**Guildford Crematorium Stack Discharge Height Error Internal Investigation**

**Date: September 2020**

## **2.0 Where did the error occur in the D1 Calculation**

Figure 6 Method of Determining Chimney Distance and Building Width

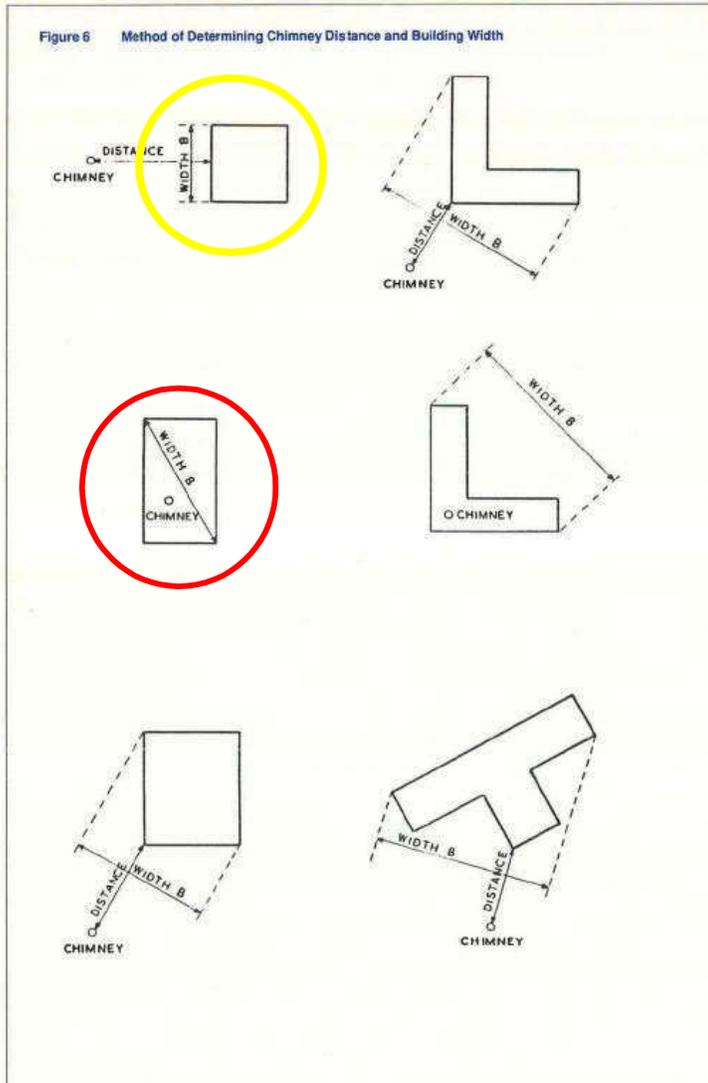
A dimension referred to as 'width' in figure 6 in the HMIP D1 guidance used a value of 3.17 metres to determine the width of the pop up roof (highlighted yellow below), whereas upon reviewing the guidance, the hypotenuse dimension across the pop up roof should have been used instead (highlighted red below), which equates to 4.672 metres.

Based on a finished pop up roof height of 7m, excluding the raised lip of 300mm on three sides of the pop up as less than 1% of the roof area as used by **[a company]**, this increases the value of T<sub>m</sub> from 11.755m to 14.008m. Inclusion of the raised lip, increasing the pop up roof height to 7.3m, further increases the value of T<sub>m</sub> to 14.308m

This has the effect of increasing the final corrected discharge height to 8.58 metres, or when rounded up takes the height up to 9 metres. This adds a further 0.9 metres to the current stack height.
